### Seismic Walkdown Checklist (SWC)

Peach Bottom Atomic Power Station Unit 3  
MPR-3812, Revision 3  
Correspondence No. RS-12-173

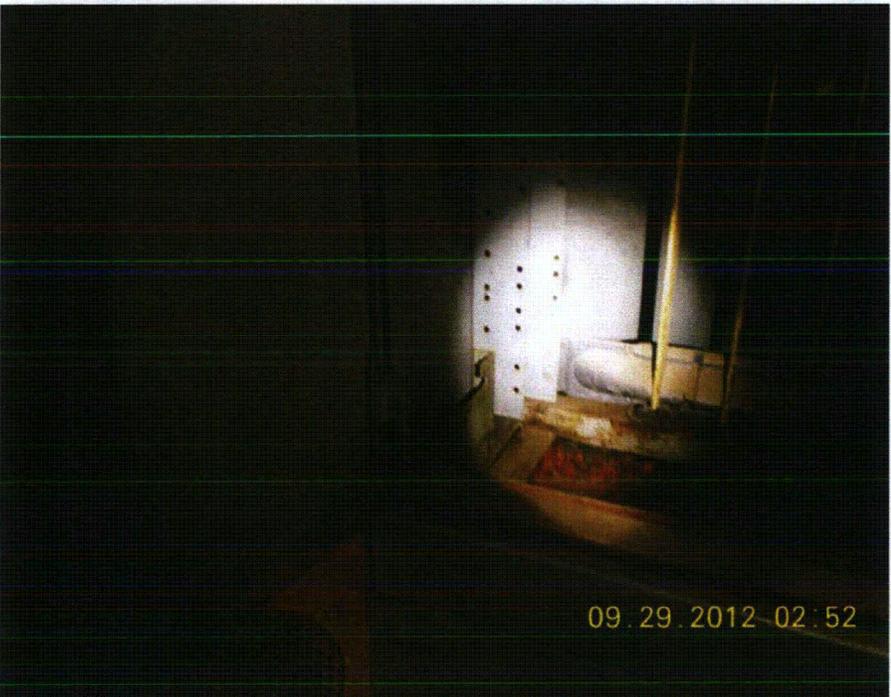
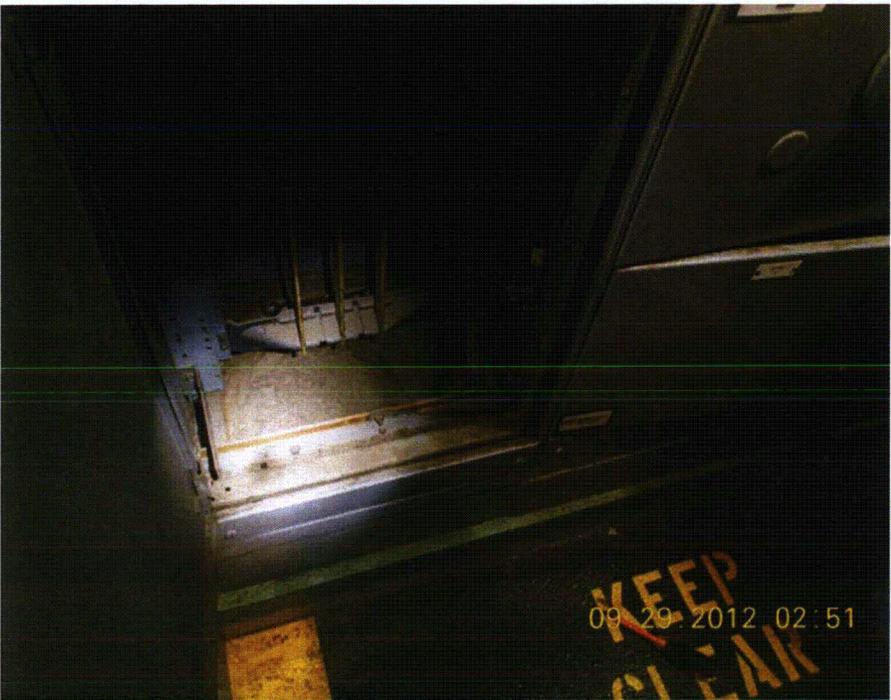
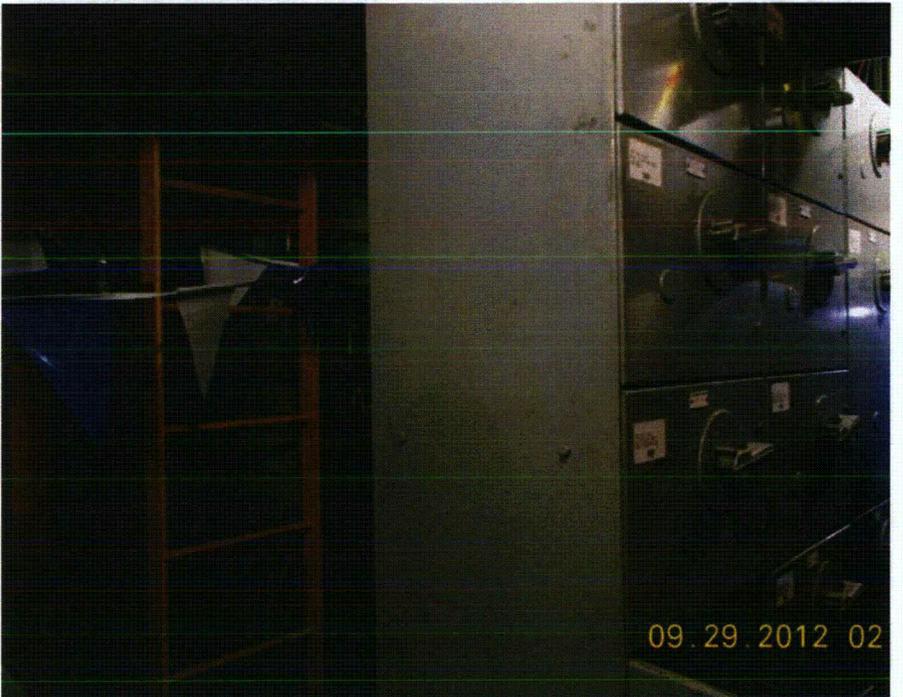
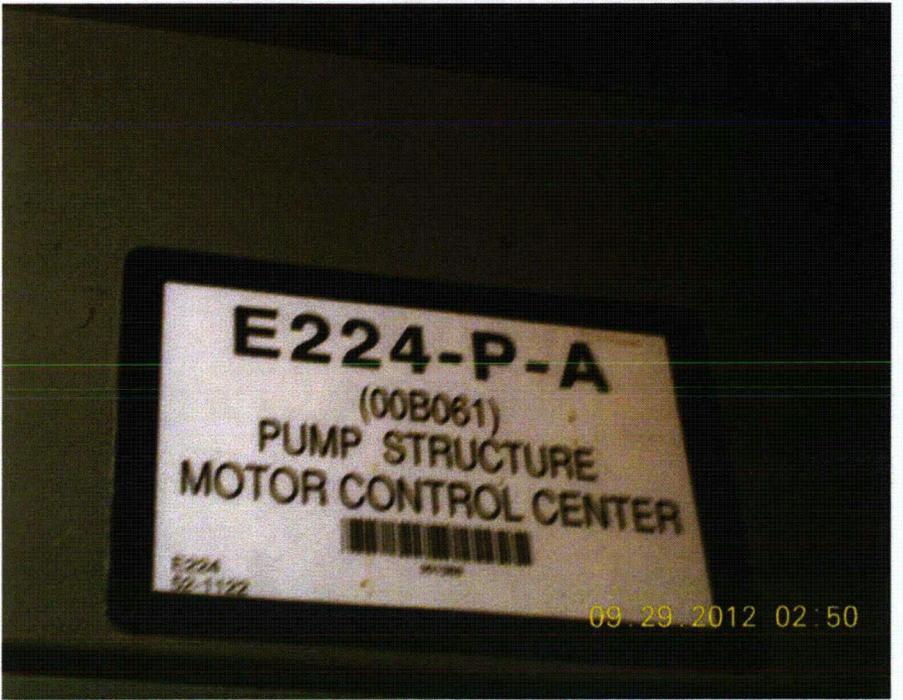
*Scaffolding + temporary outage related equipment secure*

Equipment ID: 00C029B

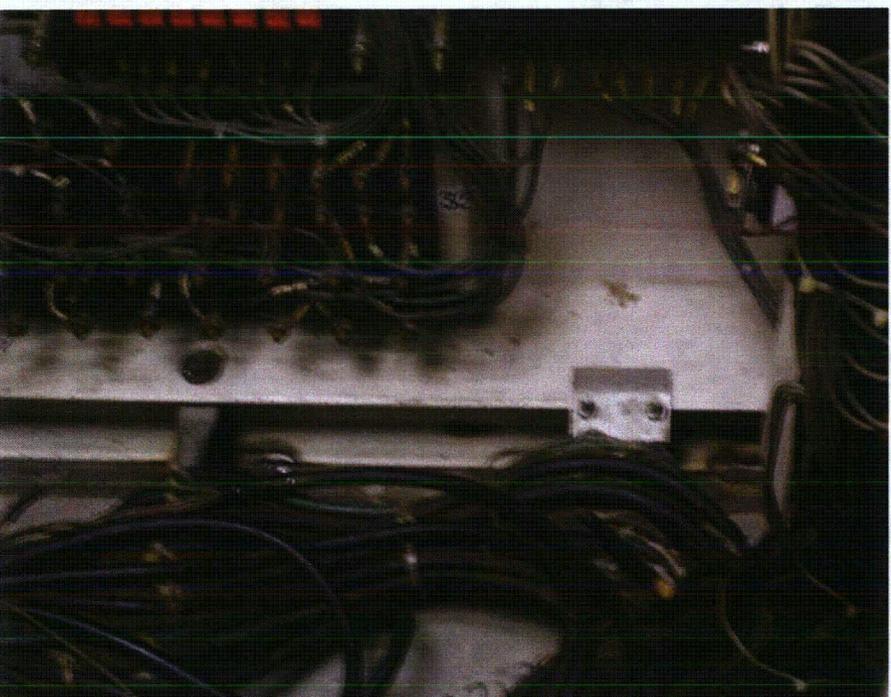
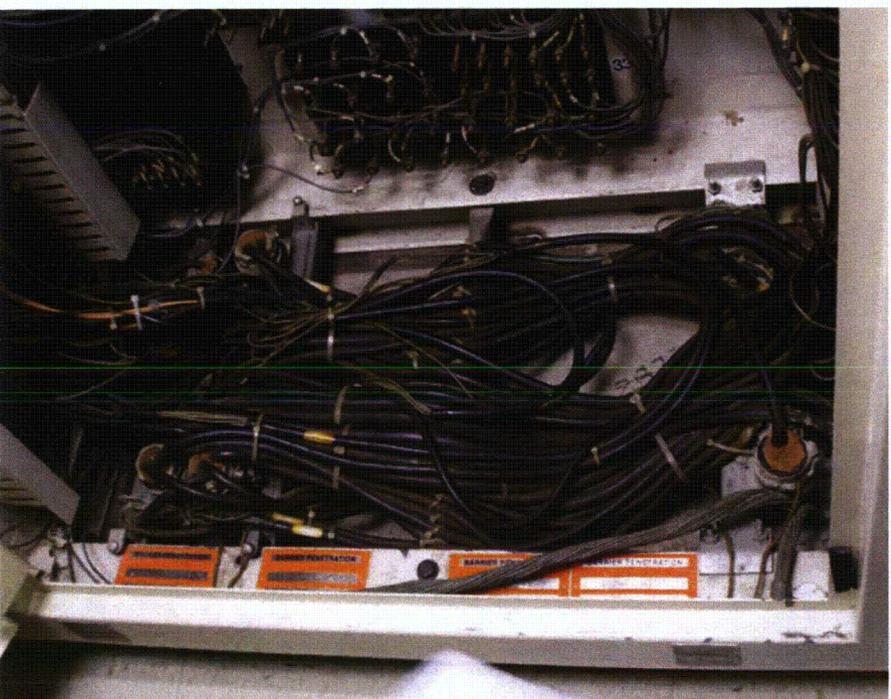
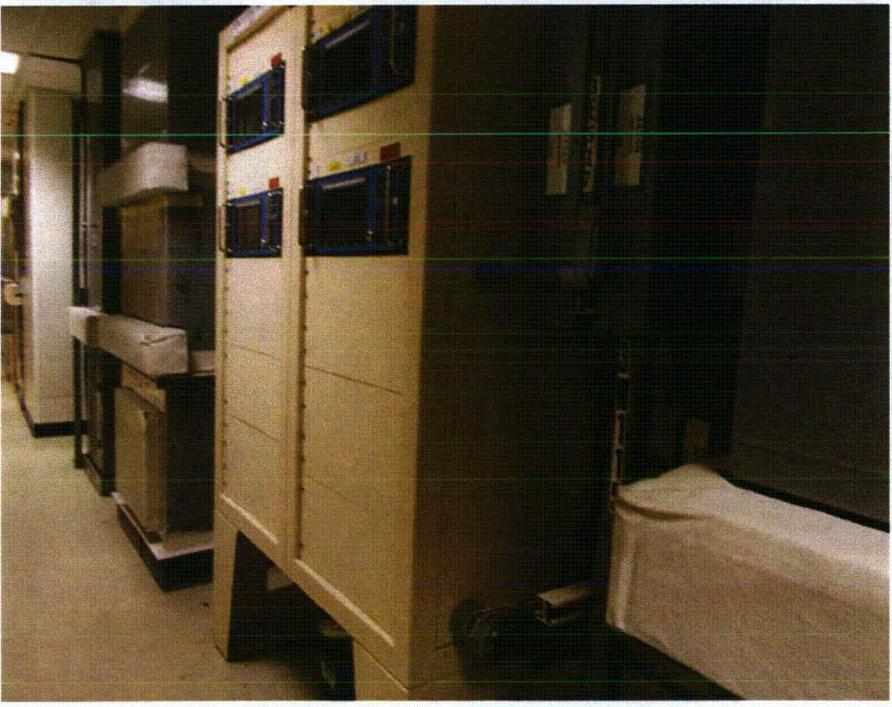
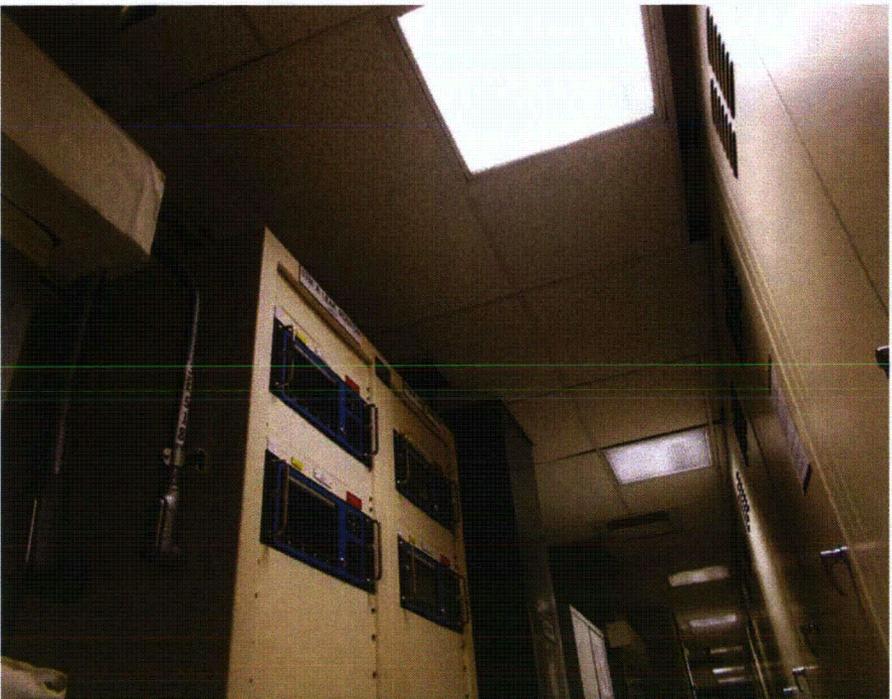
5. Is the anchorage configuration consistent with plant documentation?  Y  N  U  N/A  
 (Note: This question only applies if the item is one of the 50% for which an anchorage configuration verification is required.)  
*- Cabinet bolted to adjacent cabinets.  
 - Anchorage confirmed per ~~6200-S~~ <sup>AME 9/25/12</sup> S-1197 sheet 1 of 3, Rev 0, and sheet 2 of 3, Rev 0.*
